# Conformity of the Maritime Link Compliance Filing with UARB Condition Concerning Market-Priced Energy

submitted to the  
Nova Scotia UARB

In the Matter of the Maritime Link Act  
Matter #M05419

Low Power Rates Alliance

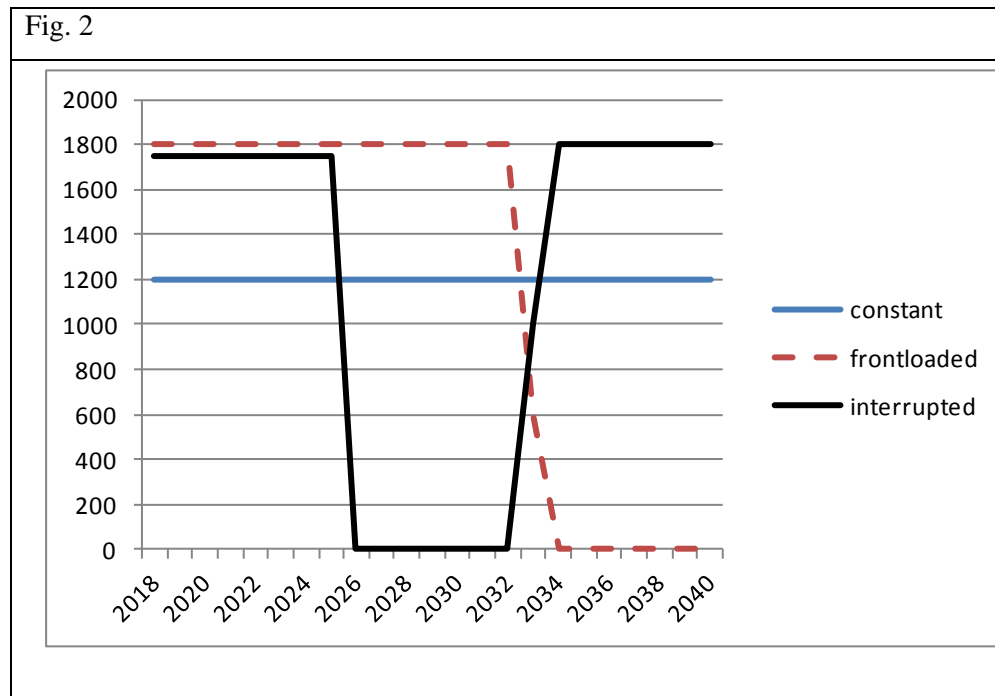
The following chart indicates a number of patterns that could result from the EAA. Each of these time series meets the Commitment, without creating Variances.

The blue line (steady deliveries of 1.2 TWh/yr) reflect the assumptions of Undertaking U-3. Each of the other lines also represents a possible, if extreme, sequence of forecasts (offerings) that would also be compliant with the EAA.

The dashed red line describes a “front-loaded” scenario, in which Nalcor’s available energy forecast is at the maximum (1800 GWh/yr) for every year starting with commissioning, until 2033. If Nalcor maintains that level of availability through 2033, its Commitment under s. 6 of the EAA will be met, even if its Forecast of Available Energy is zero from then on.<sup>3</sup>

The black line shows an “interrupted” scenario, in which Nalcor’s Available Energy is 1800 GWh/year through 2025, drops to zero for seven years, and then returns to 1800 GWh/year. Both of these scenarios are consistent with the EAA and result in Nalcor meeting its Commitment to provide 1.2 TWh of Available Energy, on average.

Let us look at how this would play out in the “interrupted” scenario described in the previous section (the black line in Fig. 2). If Energy Availability remained low in 2034, it would then become impossible for Nalcor to meet its Commitment, which would trigger a Variance. The Variance Trigger Date, following the Dispute Resolution Mechanism (s. 6.1), might be in 2035. Emera’s and Nalcor’s obligations under the Variance provisions would thus only last for 5 years.

Fig. 4: Available market-priced energy according to recent Nalcor load forecast

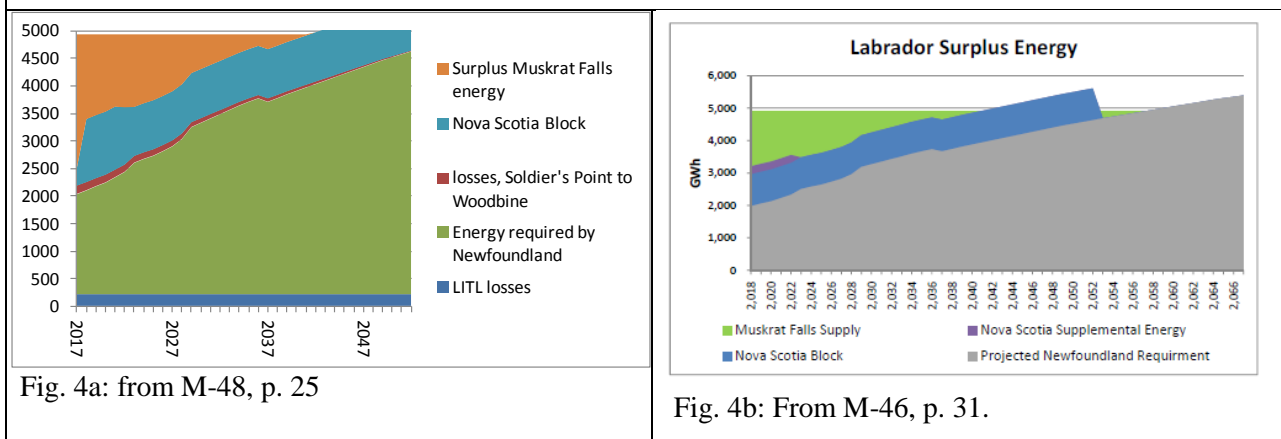
This latter type of scenario is not implausible. Nalcor will have ample surplus energy upon commissioning of Muskrat Falls. However, based on Nalcor’s forecasts of Native Load growth

in Newfoundland and Labrador, as described in my initial testimony (M-48) and that of MPA (M-46), this surplus is expected to diminish rapidly in the 2020s. In these scenarios, Nalcor’s Available Energy would decline as well, and would only recover when new generating resources are in service.

It is certainly understandable that Nalcor would insist on such a provision, in order to avoid finding itself in a situation where it is contractually obligated to serve Nova Scotia consumers before its own domestic loads. However, the Board's Condition is in large part made necessary precisely because, in such a scenario, Nalcor would be unable to provide NSP with the MPE on which it relied in IR-37. This is seen in my prefiled testimony and that of Morrison Park (M-46), shown above in Fig. 4.

Fig. 4

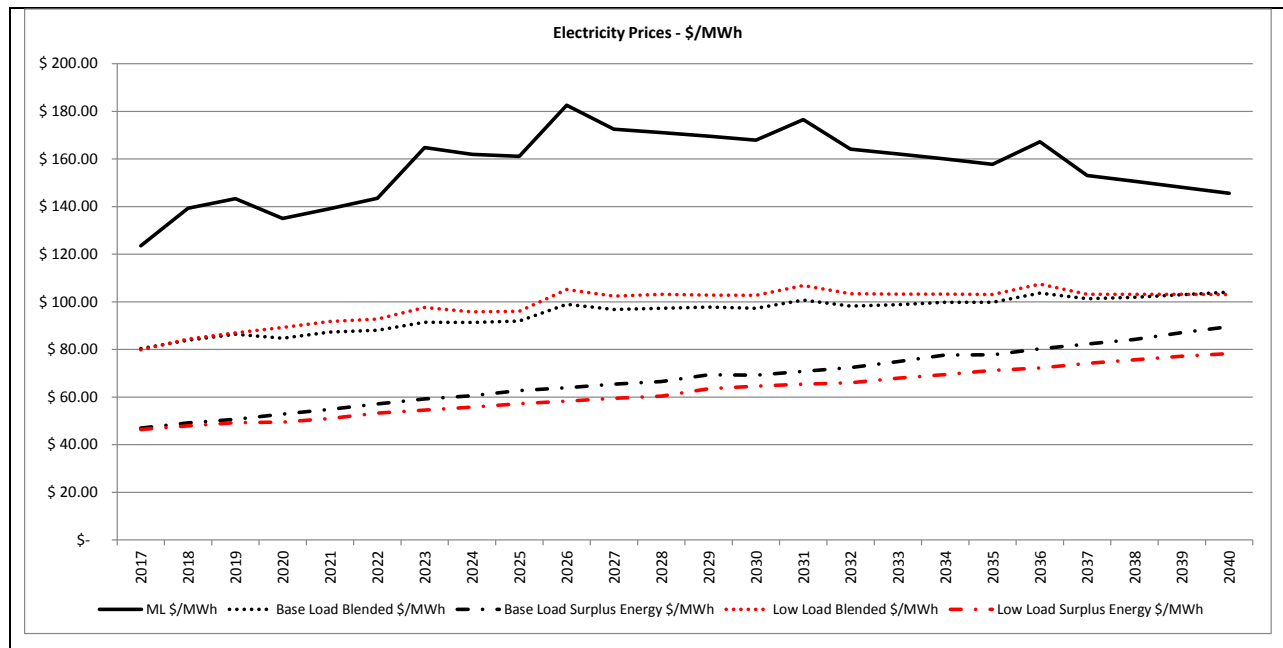
The Condition focusses on the blended price in Fig. 4-4, which was based on the Base Load scenario. The corresponding figure in Undertaking U-3, which corresponds to the Low Load scenario, includes somewhat higher blended energy costs, as seen in the red dotted line in the following chart, drawn directly from U-3:

In most years from 2020 through 2032, these blended unit costs are 5-7% higher than those in Fig. 4-4. The MPE assumption in Undertaking U-3 is that shown by the blue line in Fig. 2, but in a Low Load environment. In a Base Load context, the same reduced level of MPE (1.2 GWh on average, instead of the 1.5 TWh in Fig. 4-4) results in 4-5% increase in blended unit costs for the years 2023-2036.

Figure 5

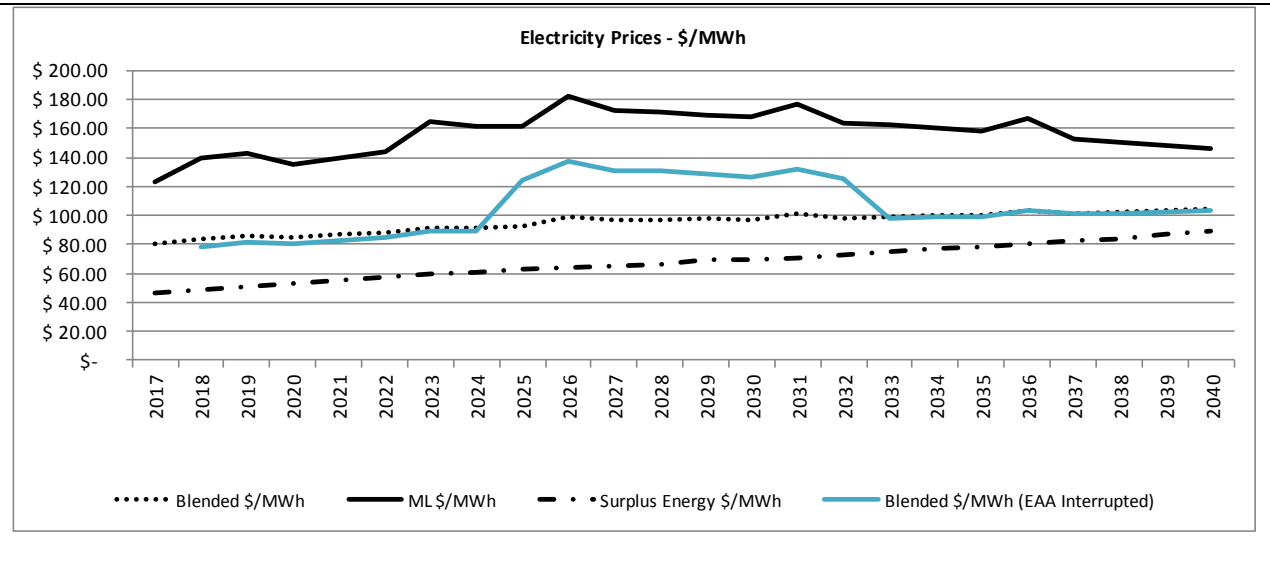
What would be the implications for blended unit costs of the “interrupted” scenario described in s. 4.2, above? The results are shown in Figure 5.

In the years when Available Energy is zero, blended unit energy costs would be 30-40% higher than the levels indicated in Fig. 4-4. Over the entire term, the undiscounted average blended energy cost would be more than 11% higher. Again, given the very slight superiority of the Maritime Link Project identified in the NPV analysis, this difference could well be enough to shift the balance, such that the Maritime Link Project would no longer be the least cost alternative.

Fig. 6

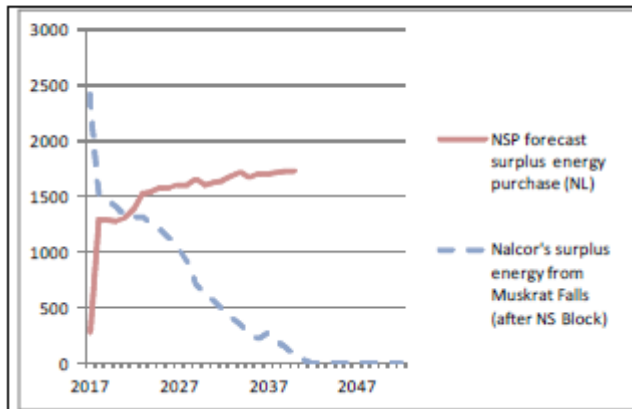
And what if available MPE should follow the pattern shown in Fig. 4a, above? In this scenario, Nalcor's Available Energy falls off rapidly, as shown in Fig. 6.

In the Base Case scenario, as seen in Fig. 6, above, assuming no new resource development, Nalcor's surplus energy would fall below the amounts required in Fig. 4-4 as early as 2022.

Fig. 7

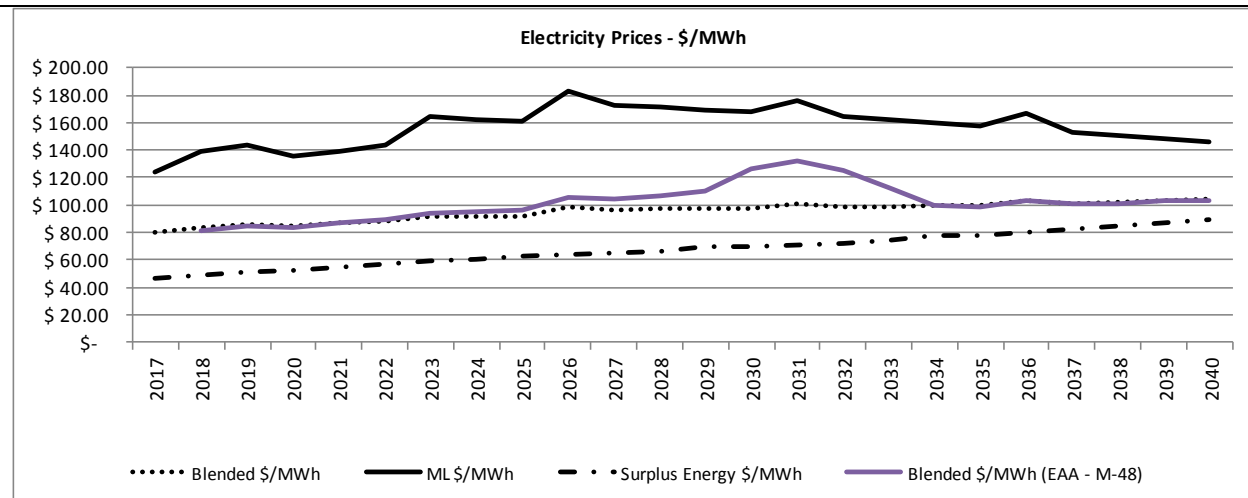
The blended unit costs in this scenario would be 6.1% higher than in Fig. 4-4, as shown in Fig. 7.

Fig. 9: RES-eligible supplies vs. Requirements (Base Load case, surplus energy imports not RES eligible)

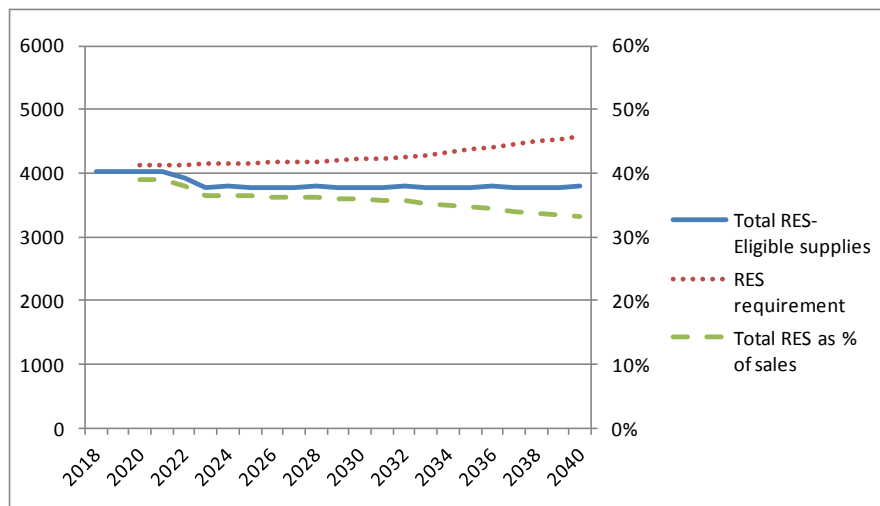
Under the EAA, ML market-priced energy is clearly not RES-eligible. As a result, under the Base Load scenario **NSPI will fail to meet its RES requirement for every year, from 2020 on**, as seen in Fig. 9.

**Thus, under the EAA and the Base Load forecast, NSPI would be unable to meet the RES requirement in any year, from 2020 on.**

Fig. 11

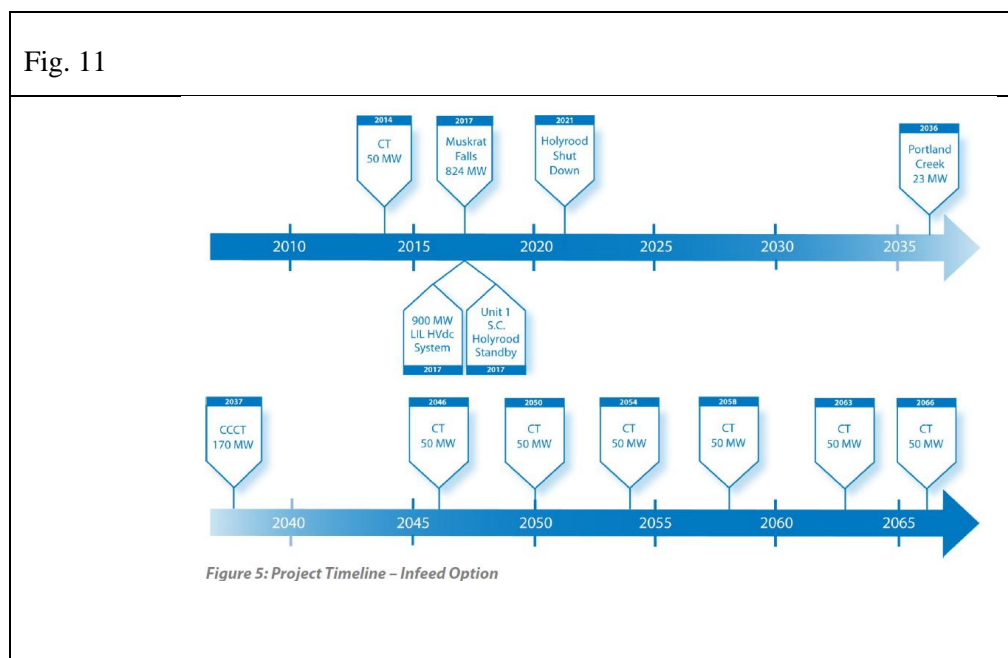
This last statement is simply incorrect. New thermal power played an important role in the Infeed Scenario presented by Nalcor to the NLPUB. This graphic representation, drawn from the MHI report commissioned by the NLPUB, shows that, after Muskrat Falls and Portland Creek, the next planned resource was a 170 MW combined cycle turbine.<sup>10</sup>
